# Determination 2026/017

**The issuing of a certificate of acceptance for work completed on a new shower room, and whether the building work complied with the building code.**

**110a Lynwood Rd, New Lynn, Auckland**

**Figure 1: The shower room**

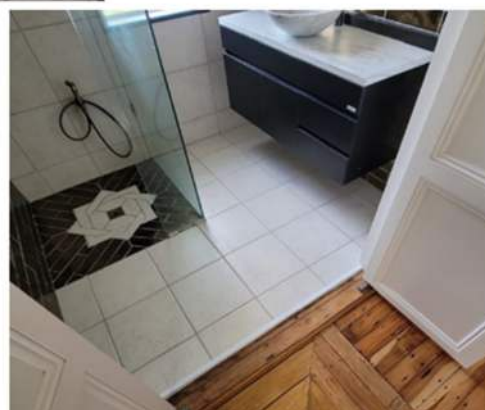
- 1.3. This determination arises from the authority’s decision to issue the certificate of acceptance (COA04522498) (“the COA”) for alterations to an existing dwelling to create a new shower room where a previous bathroom existed (refer to figure 1). The current owners believe the building work does not comply with the Building Code and the COA should not have been issued.

**Figure 2: View in subfloor space below the floor waste and wash hand basin**

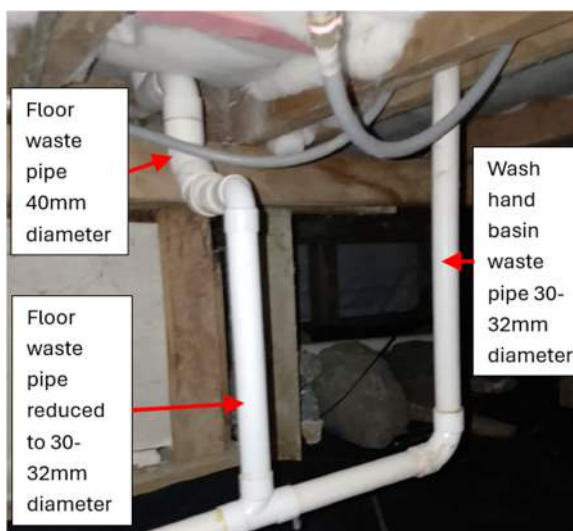
- 2.2.16. As-built information confirms a 30 – 32mm diameter pipe was installed to the wash hand basin. A 40mm diameter waste pipe is installed to the floor waste (refer to figure 2) but it reduces in size to 30 - 32mm in diameter part way long its length (in the direction of flow of water). This pipe connects onto the discharge pipe from the wash hand basin (refer to figure 2).

- The reduction in size of the floor waste pipe in the direction of flow (up to and including where it connects with the smaller diameter wash hand basin discharge pipe) does not avoid the likelihood of blockage.

- 4.15. The reduction in pipe size from the floor waste to the discharge pipe does not comply with either the specified standard AS/NZS 3500.2 or with Acceptable Solution G13/AS1. Both provide for untrapped floor drains, but have minimum diameter requirements of 40mm, either for the floor waste (G13/AS1 paragraph 3.4.2) or the discharge pipe it connects to (AS/NZS 3500.2 paragraph 13.26.3). Neither provide for a reduction in pipe size along the direction of flow.

- 4.17. Reducing the diameter of a waste pipe in the direction of flow can have several effects, including (but not limited to) lowering flow capacity by restricting the cross-sectional area, increasing frictional resistance, turbulence, and pressure loss. Larger waste pipes connecting onto smaller waste pipes also increase susceptibility of debris accumulation in the pipe, progressively narrowing the flow path and increasing the risk of bottlenecks and blockages. In summary, the reduced diameter of waste pipe in the direction of flow does not avoid the likelihood of blockages over the intended life of the building, meaning compliance with clause G13.3.1(b) has not been satisfied.

**Figure 3: View of ventilation fitting installed to wash hand basin waste pipe**

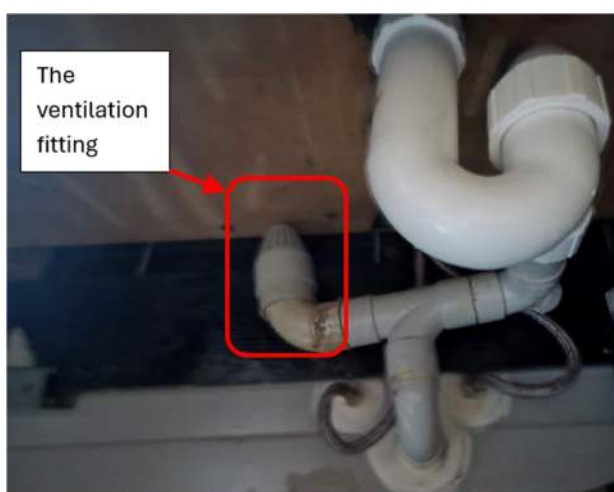
- No trap has been installed to the floor waste, so it does not avoid the likelihood of foul air and gases entering the building.
  - A ventilation fitting has been installed to the wash hand basin discharge pipe that does not avoid the likelihood of foul air and gases entering the building.

- 4.23. The issue relates to a ventilation fitting installed to the wash hand basin discharge pipe. The ventilation fitting, with open slots around its circumference, appears to be a vent cowl (usually installed to a vent pipe external to a building). Based on the photographs provided by the parties, it has no features that suggest it has a valve of any description to avoid foul air and gases from entering the building (like an air admittance valve).
- 4.24. As it presents, the ventilation fitting below the wash hand basin does not avoid the likelihood of foul air and gases from the plumbing system from entering the building (ie in the shower room), meaning the as-built work does not comply clause G13.3.1(c).
